**TO:** Historic Preservation Board  
**FROM:** Department of Doing, Planning Staff

**DATE:** November 07, 2017

**SUBJECT:** Petition HP-17-51. Edie and Gerlach James, owners, Jay Reeves agent. Application for Certificate of Appropriateness, Ad Valorem Tax Exemption (Part 1) and Zoning Modification. Located at 716 SE 4th Ave. The work includes a master bedroom suite addition, a front porch, relocation of windows and doors, replacement of existing windows, a new carport and connector, a new chimney, a new courtyard wall and fencing. The zoning modification request is for 4'-0" at the side yard setback and for 9' at the rear setback. The property is contributing to the Southeast Residential Historic District.

ADDITIONS TO THE JAMES RESIDENCE  
716 SE 4<sup>TH</sup> AVE GAINESVILLE, FLORIDA

PROPOSED PLAN

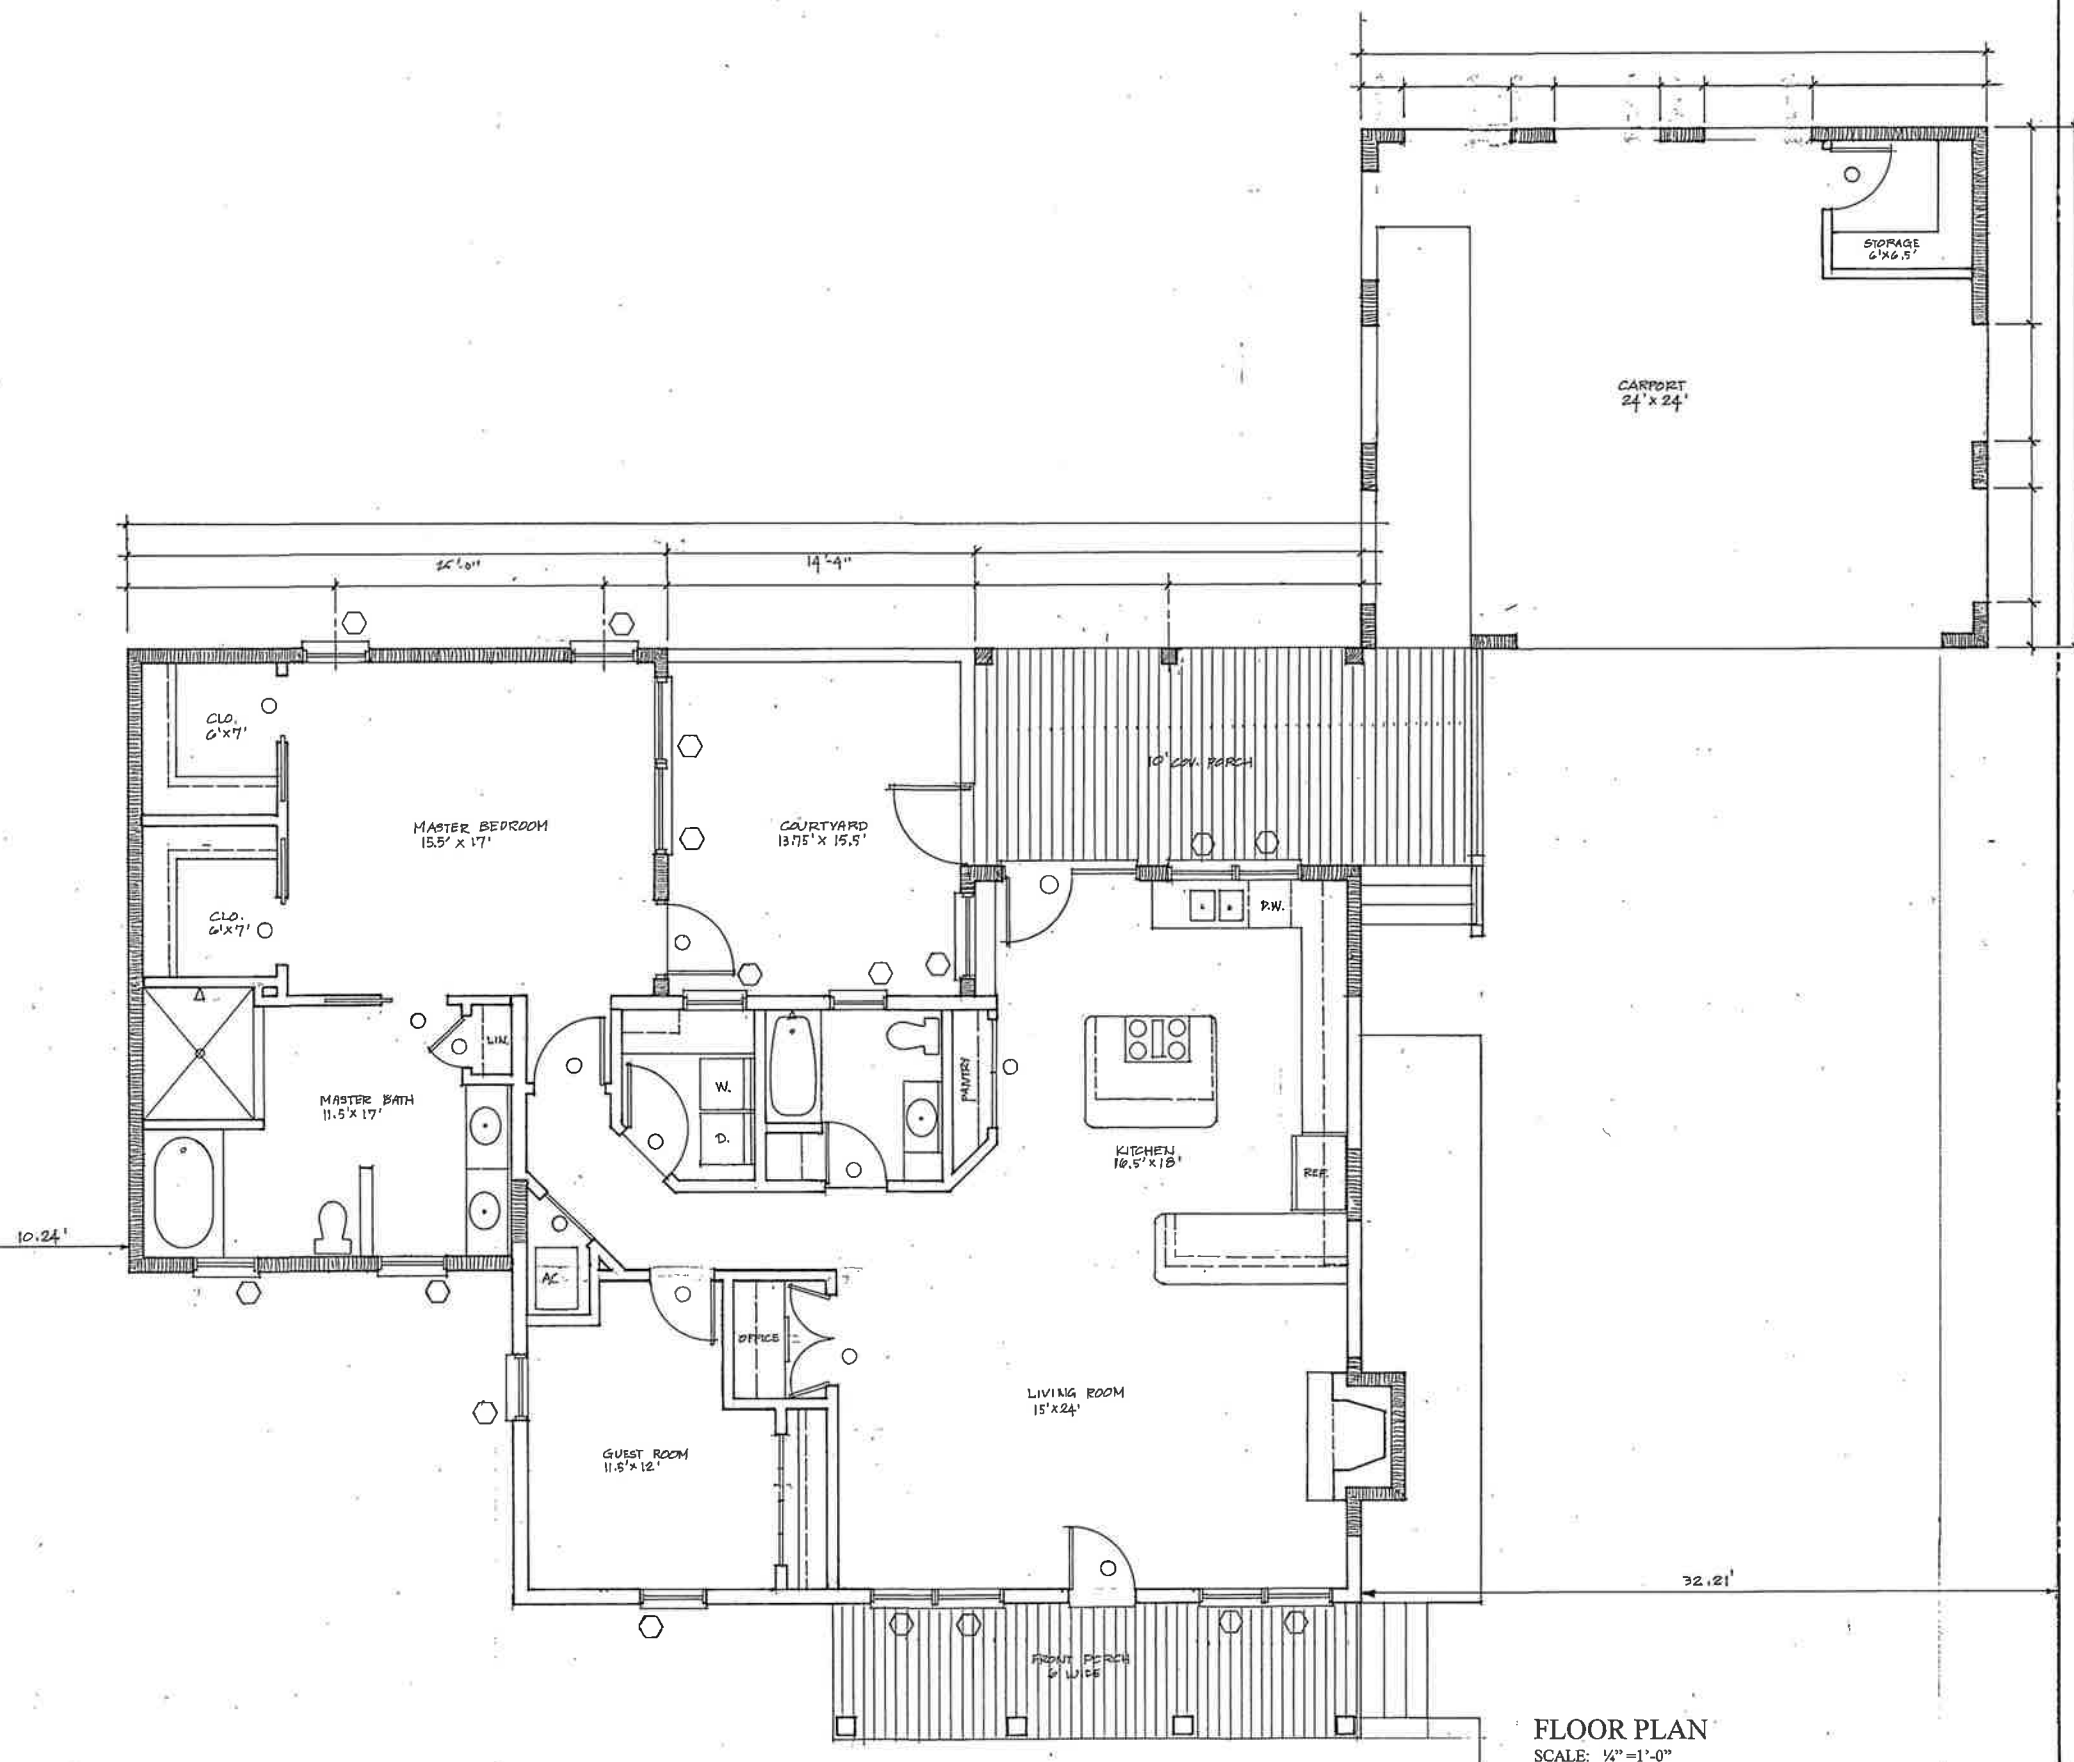
Referencing Guidelines “Additions to Existing Buildings,” Staff comment: The additions are located to the rear of the original house, “designed to minimize impact of the visual character and materials of the historic structure” (p. 90). The additions are compatible with the massing,

materials and openings, and clearly identifiable as an addition. Staff finds the two additions appropriate.

Window Alterations: It is not recommended to “introduce or change the location or size of windows....that alter the architectural and historic character of the building” and “window openings on facades or highly-visible elevations shall not be relocated, enlarged or reduced” (p. 102-103). Door relocation: It is not recommended to “introduce or change the location of doors and entrances that alter the architectural character of the building.” “Original door openings and features should be retained..” (p. 109). Staff finds the window and door alterations on the rear and side of the house compatible, as they are on secondary facades. Staff is concerned about the relocations of the front windows and doors to create a formal, symmetrical entry on the new porch. In conjunction with the formal designed porch addition, Staff feels this does alter the original architectural character of the building. The existing door has a stoop, which really “weighs” the entry more to the east side of the house; there is nothing formal or centrally symmetrical about the existing entry. Staff would consider allowing the change of door and window location, if the porch re-design reflects more of the original asymmetrical design. See next section.

Referencing Guidelines “Porte Cocheres and Garages,” Staff comment: Staff finds the proposal for the carport generally acceptable as it is located to the rear of the house and does not destroy and historic features of the house. Staff recommends the design of the carport be more reflective of the mid-century era of the house, such as simplifying the brick piers and possibly creating a lower sloped roof. Staff is concerned that a hip roof over the two-car carport, at a width of 24’, presents a lot of roofscape that is visible from the street. Further, if the carport is a separate structure but to be connected to the house, using a lower-slope connection would minimize the roofs visibility.

This lot is located in the Urban 3 transect zoning. The carport will require a side yard reduction at the east property line to 4’-0” where 5’-0” is required. The adjacent house is approximately 3’-0” off that property line. The carport is also requiring a 9’-0” rear setback where 10’-0” is required.

side setbacks, and as the carport is a mostly open structure, Staff recommends approval of the modification.

Staff approves the location and height of the brick wall at the courtyard, as the wall doesn't affect any of the adjacent property. Staff recommends its design elements reflect the mid-century design of the house. Staff requests the applicant submit a plan showing location of fencing, as well as a drawing showing picket style, spacing, and post dimensions and spacing. As the house is mid-century era, Staff would recommend a simple fence design. If the requirements of the fencing guidelines are met, Staff can review the submission without Board approval.
